Highlights of Technical Analysis for TexCom's Permit Application WDW-410 Class I Well

An Oversight Exercise by EPA, Region 6

Highlights of Technical Analysis for TexCom's Application – WDW-410 Class I Well

A Discussion on Relevant Parameters, Parameter Values, Injection Reservoir Pressure Build Up Modeling, Aquifer Contamination Risk Assessment for Permitted Operation and UIC Program Performance Assessment

The Permitted Injection Zone

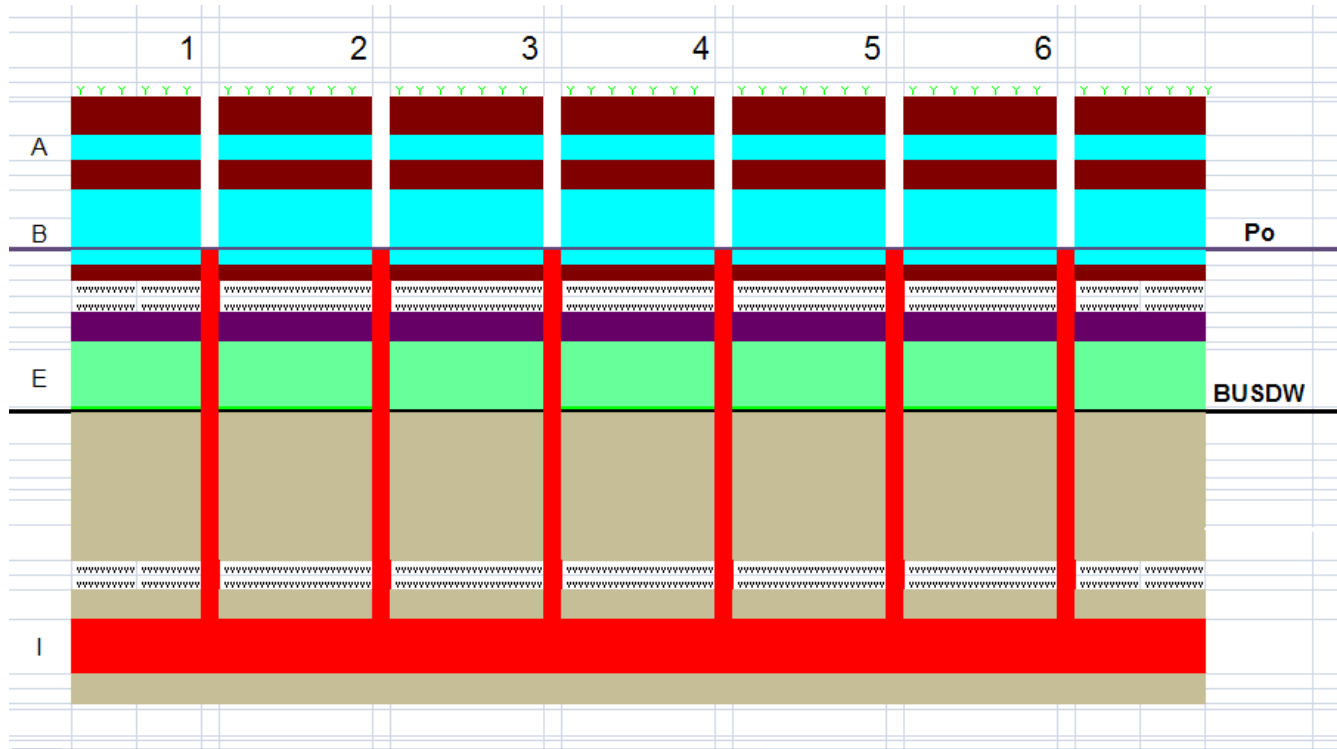
The argument was made that no remedial measures were necessary regarding the potential for vertical migration of fluids through the large number of wells that could potentially provide a pathway out of the injection zone, because those wells would have undergone “natural closure”.

My assessment is that, without data on “natural closure”, specific to Montgomery County, the argument on well “natural closure” would appear to be an unproven hypothesis.

As a result, no scientific data seem to be available on which to base an important decision such as that of not requiring the plugging of wells which might potentially allow the injected fluids, and native fluids to leak out of the injection zone under pressure.

As noted, the Upper Cockfield is an oil producing horizon, and **it has been made part of the injection zone**. Waste injected into the Upper Cockfield is bound to find its way out of this zone through producing wells.

The Conceptual Reservoir Fluid Mechanics Model for WDW-410 Prior to Injection

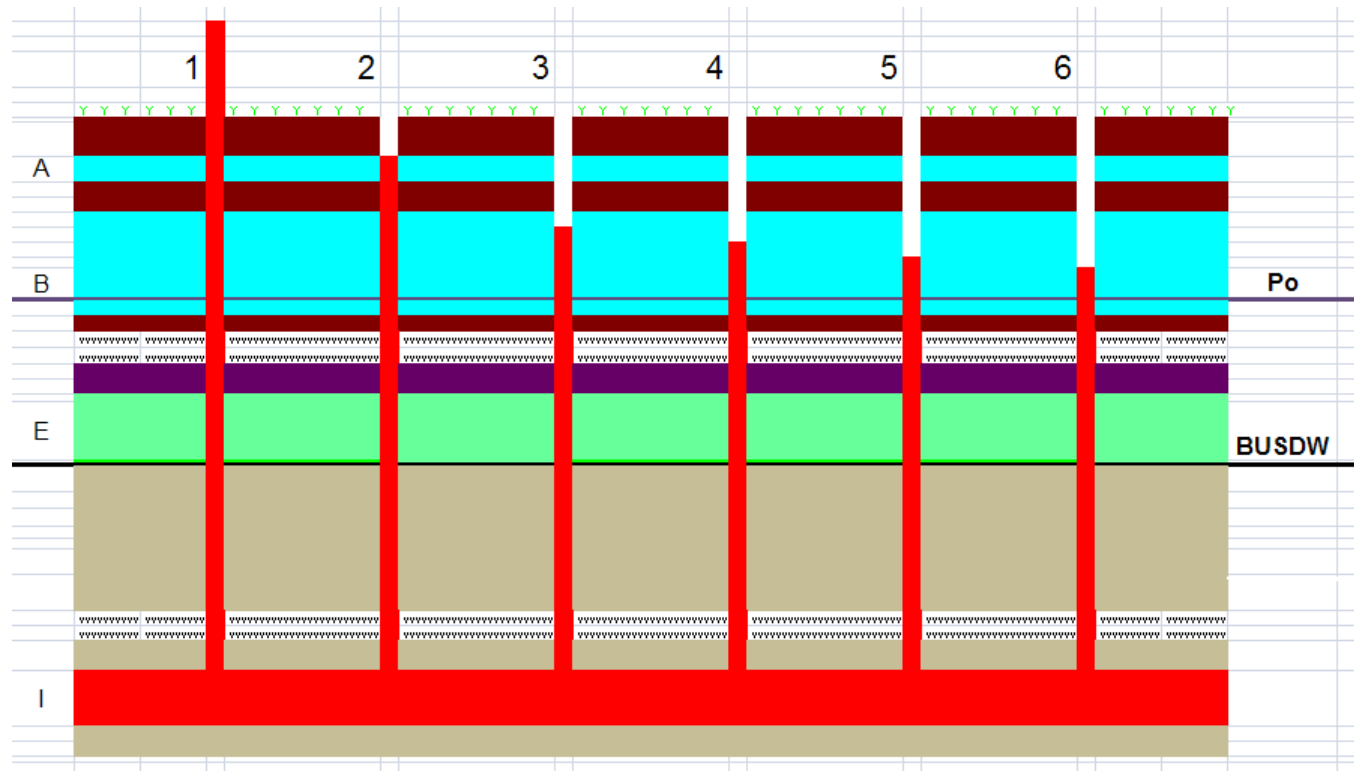
The above generic cross section illustrates the presence of several USDWs: A through E. Wells 1 through 6 penetrate, and are in hydraulic communication with, deeper Aquifer I. All areas of Aquifer I are hydraulically connected.

The fluid level (hydrostatic column) in these wells attests to the [initial reservoir pressure](#), P_o , in Aquifer I.

P_o is of such magnitude that it places the piezometric surface of Aquifer I **above the base of the USDWs (BUSDW)**. Fluids in Aquifer I could **potentially flood** the existing USDWs, per the above model.

The TexCom provided field data indicate that **the initial static condition of the target injection zone in the WDW-410 well is similar to the situation illustrated above**, as far as the disposal system's initial fluid mechanics is concerned.

A Conceptual Reservoir Fluid Mechanics Model Prior to Injection

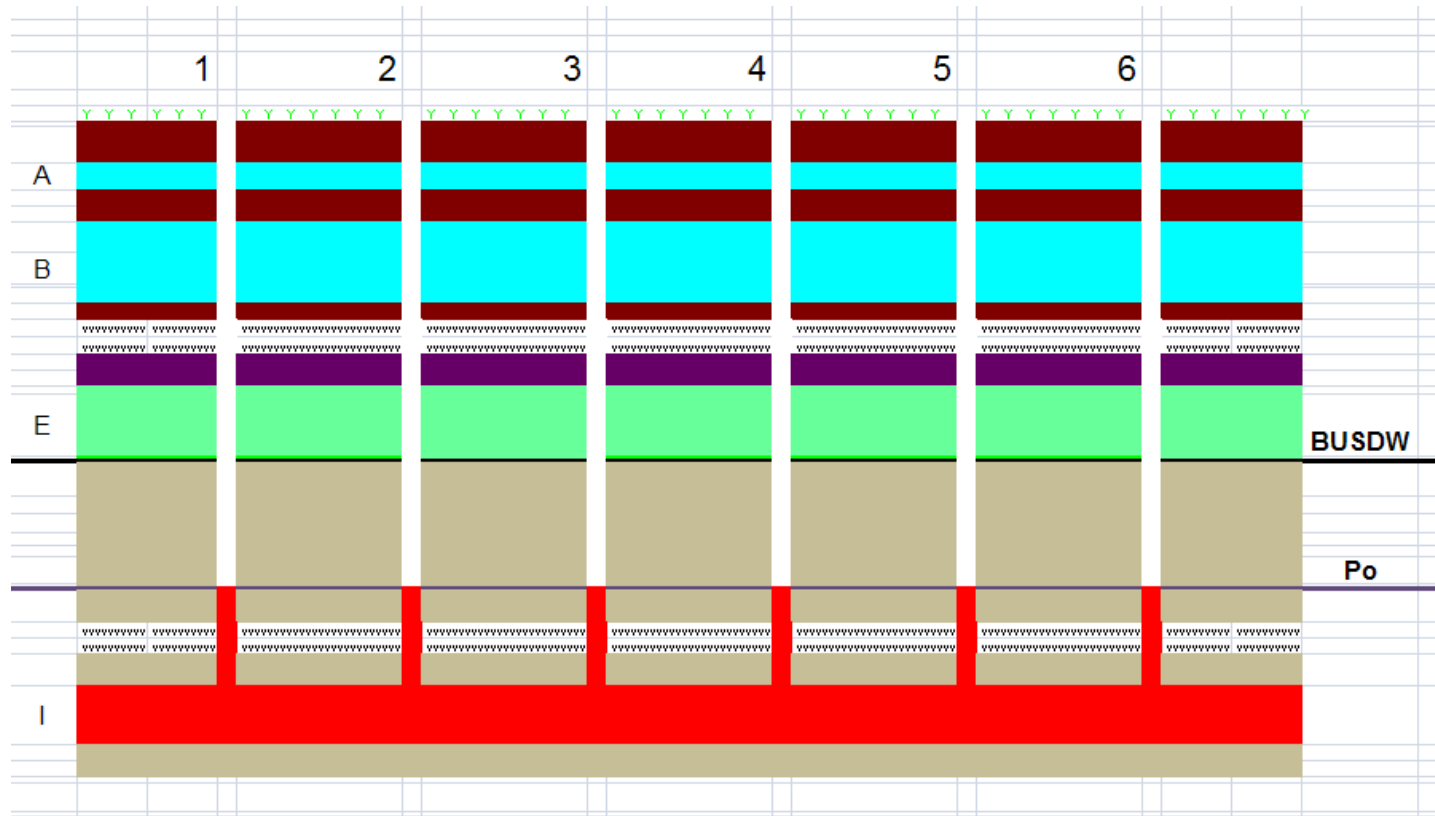
The above cross section is similar to the first presented cross section. The only difference here is that the illustrated reservoir pressure, P_o , in Aquifer I is of a lower magnitude and, as a result, the piezometric surface for this Aquifer is found below the base of the USDWs (BUSDW).

In this model, and prior to injection, the risk for movement of fluids from Aquifer I into the USDWs is zero.

This is basically the model used by all parties that argued in favor of the approval of the TexCom permit application, with P_o set, for all practical purposes, at 0.0 psi.

A Conceptual Reservoir Fluid Mechanics Model During Injection

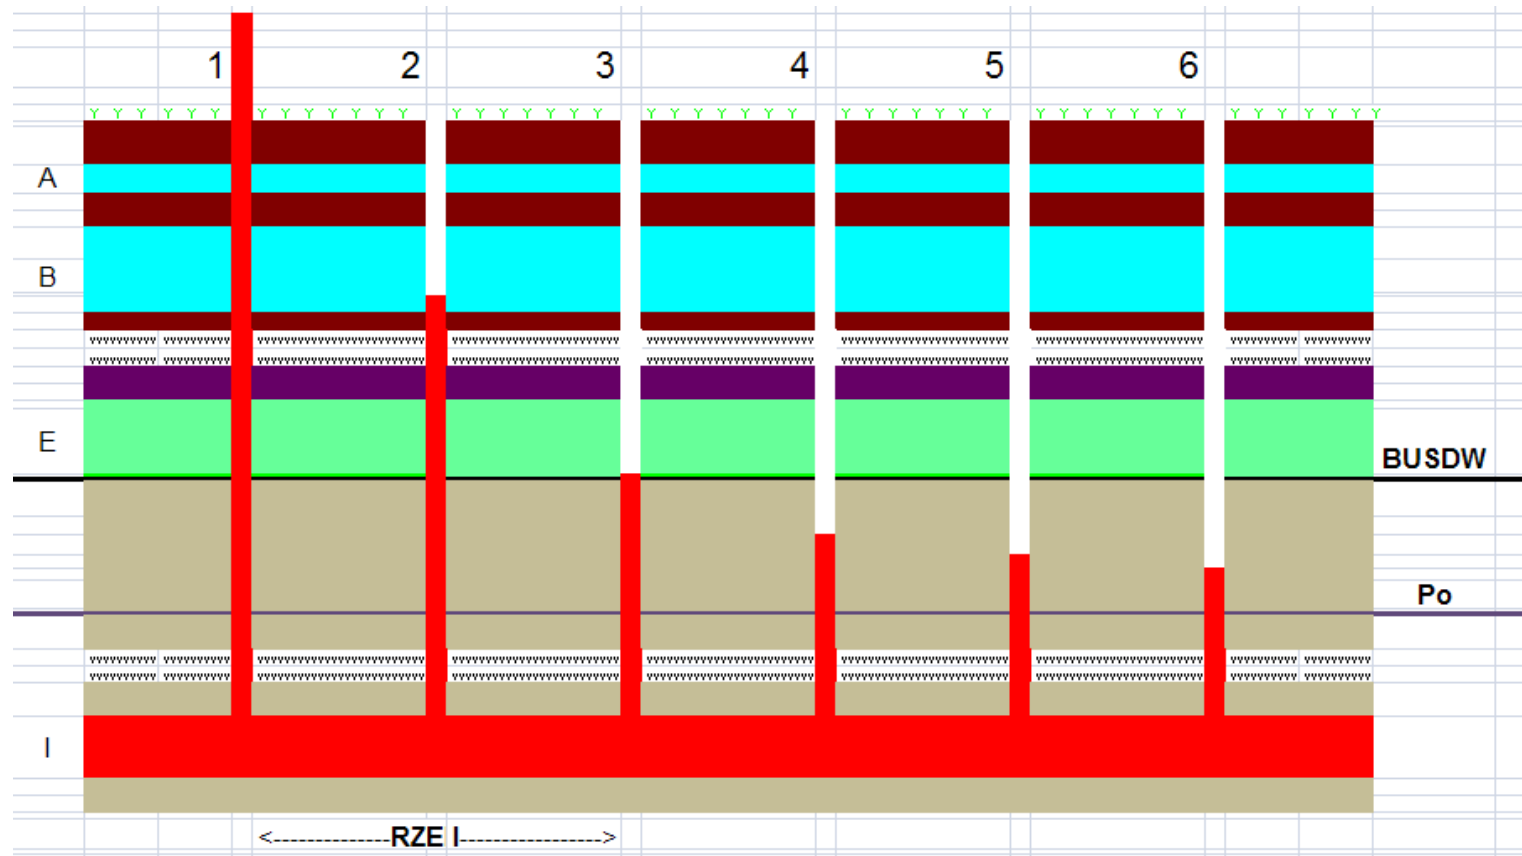
This cross section also illustrates the pressure effect of injection into Aquifer I, through injection Well 1, over a certain period of time.

It can be seen that, as a result of injection, the reservoir pressure at Well 3 is of such magnitude that it may cause liquids inside Aquifer I to potentially flood (contaminate) USDWs.

The distance between Well 1 and Well 3 is called the Radius of the Zone of Endangering Influence (RZEI), or **Radius of Endangerment, RE** (slight variations of this model may result from consideration of other well and aquifer conditions).

Modeling the Reservoir Pressure Response Effected by Injection

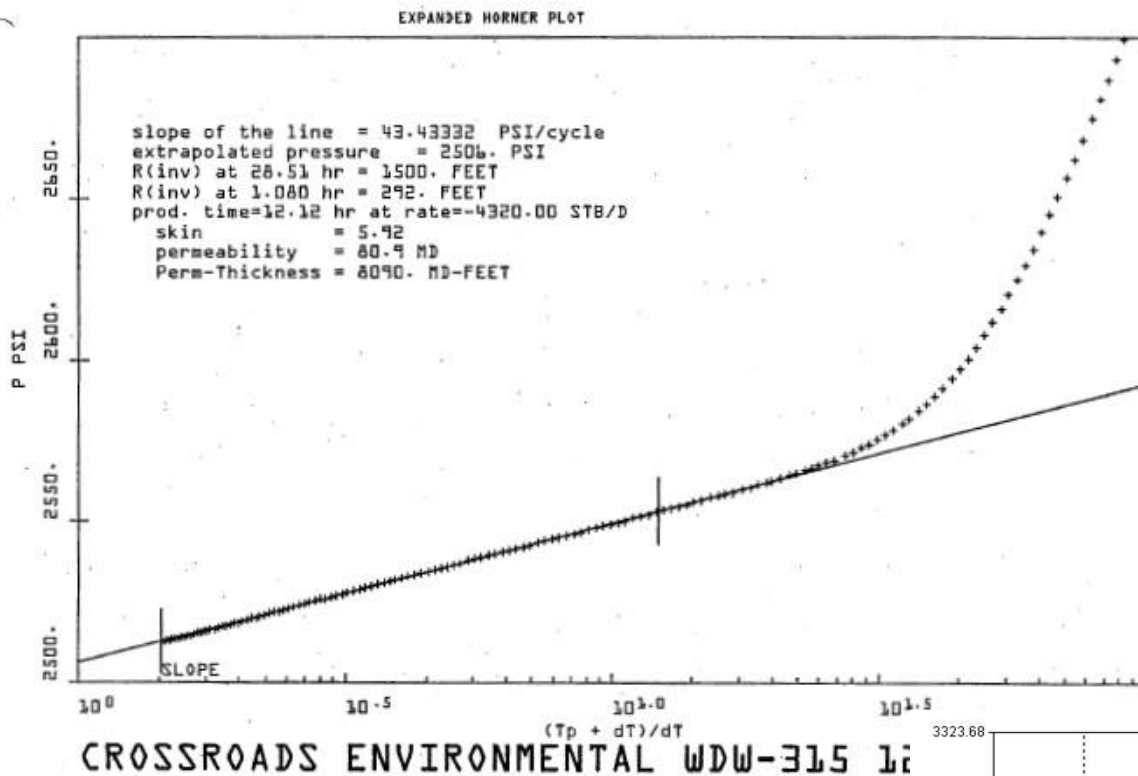
The mathematical model below is often used to evaluate the [risk of contamination](#) that an injection operation might induce. This model lends itself for what has been called by some “back of the envelope” computations.

In exercising its oversight authority, EPA R6 carefully reviewed, among other things, the process for obtaining the parameters relevant to the technical evaluations submitted by the parties, along with the proposed parameter values.

As can be seen in the above mathematical model, the initial reservoir pressure, P_e^* , the fluid viscosity, μ , the injection interval thickness, h , the injection zone permeability, k and porosity, ϕ , are some of the parameters of interest.

[Initial Reservoir Pressure \$P_e\$ in
the Permitted Injection Interval:
The Lower Cockfield Sand](#)

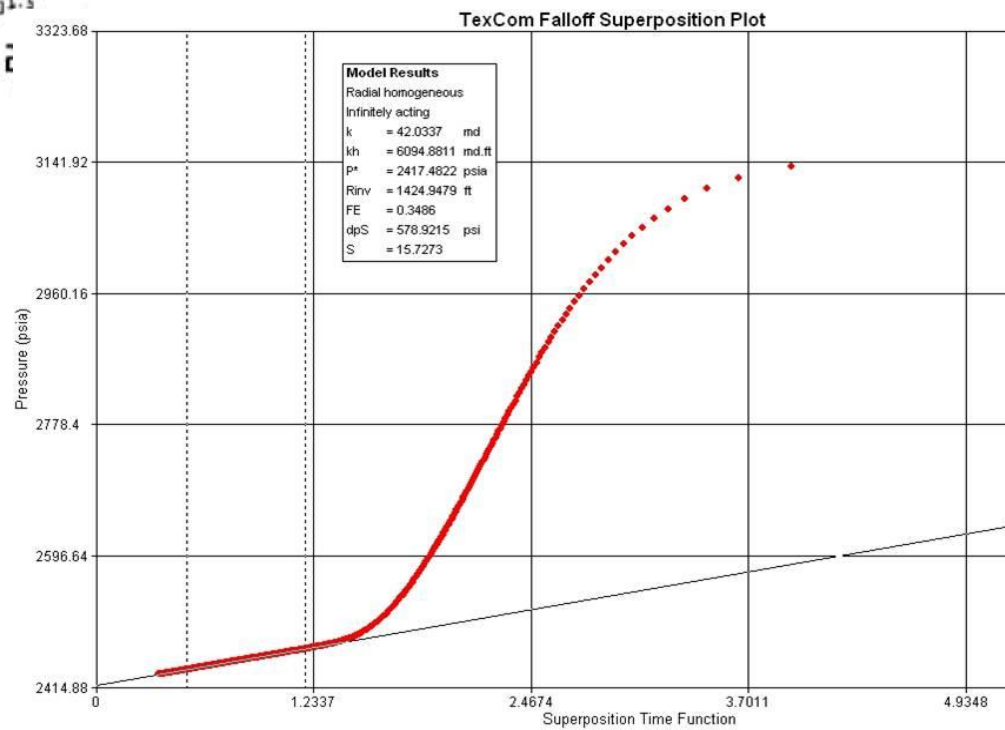
The base of the USDWs in the WDW-410 well has been estimated at **4088 Ft.**

The 1999 Fall-Off Test indicated a static reservoir Pressure of **2506 psia** at **6200 Ft**

The 2009 Fall-Off Test indicated a static reservoir Pressure of **2417.5 psia** at **6000 Ft**

These pressure readings put **the fluid level** inside the permit well at roughly **690 Ft** from the surface.

Since factual data show that **P_e is not zero**, and that, if given a flow path, the Lower Cockfield's fluids can migrate upward, beyond the base of the USDWs, it seems appropriate to say that the first two discussed cross sections model the fluid mechanics at WDW-410.

Reservoir Permeability **k** in the Lower Cockfield

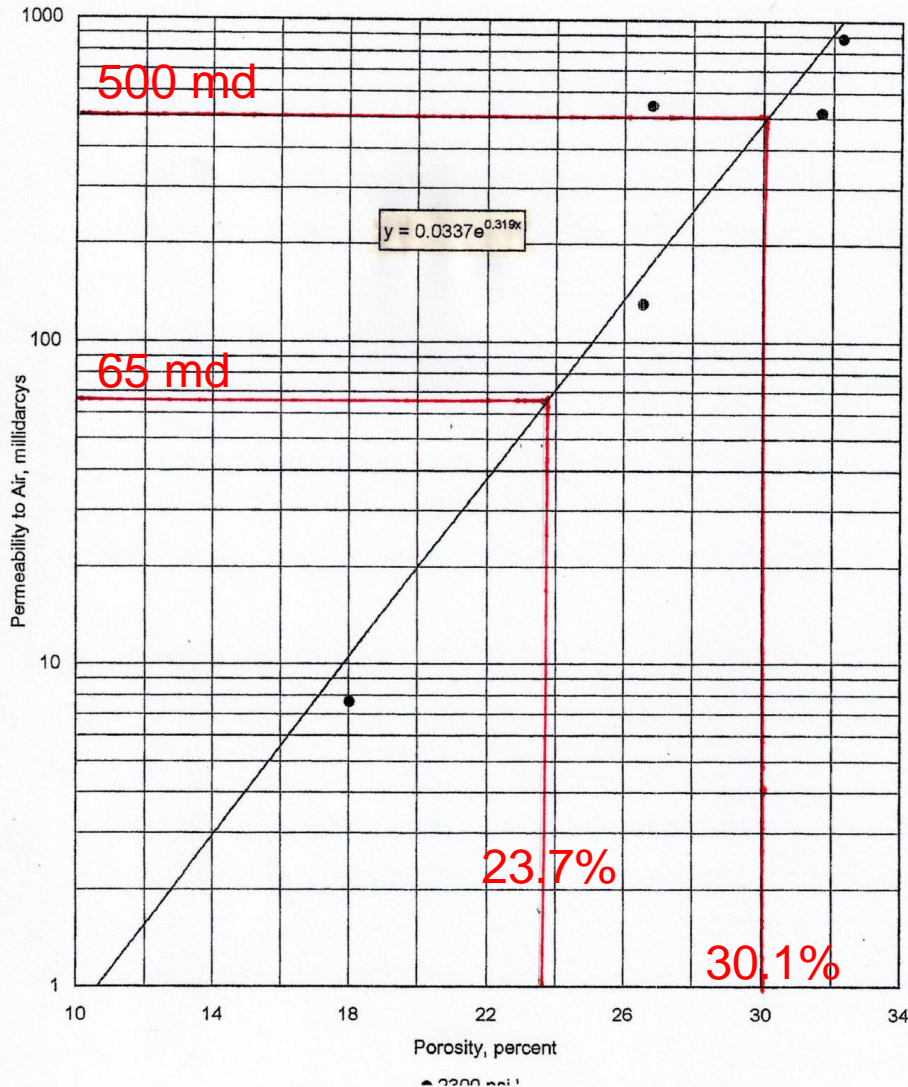
A 14 foot core from the Lower Cockfield was available for the WDW-410 well.

The shown excerpt from the lab report suggests that **five core plugs were analyzed** for **air permeability** and other parameters.

There is no evidence that results for whole core analysis are available.

VII.B.4 Permeability and Skin

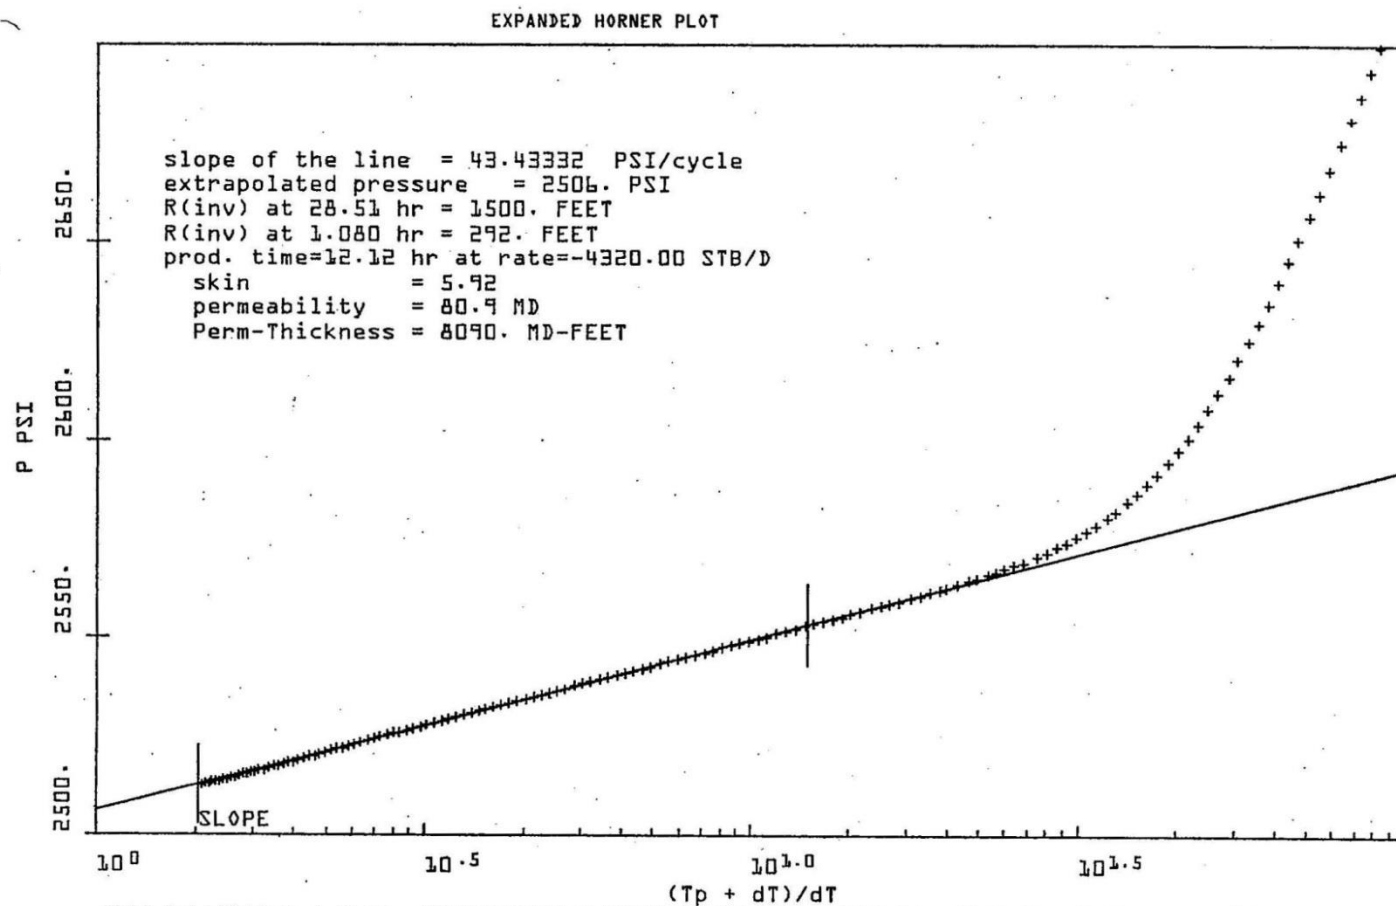
Permeability is the capacity of porous media to transmit fluids. An averaged homogenous permeability of 80.9 md was determined from a well testing event performed after the initial well completion in December 1999. Based on review of the perforation record, log analysis, and core analysis performed on the well it is believed that the derived permeability from the well test analysis is not representative of the reservoir conditions. Estimates of reservoir permeability has been as high as 1,400 md based on literature review. Core analysis conducted on the Lower Cockfield indicated a permeability range of 550 md to 850 md for the portion of the formation planned for perforating after permit approval. A reservoir permeability of 500 md was used in the modeling effort based on the review of logs and core analysis. This value is believed to be more representative of the injection zone and still considered to be a conservative number.

The above excerpt from the application package illustrates efforts to legitimize the use of a permeability of 500 md in the assessment of the risk of contamination for the proposed injection operation. Similar arguments were presented as expert testimony.

However, as seen in the available cross-plot, a permeability value of 500 md corresponds to a porosity of about 30.1%. The discussions on porosity presented below show that the available engineering data do not validate an average porosity of 30.1% for the injection interval in the Lower Cockfield.
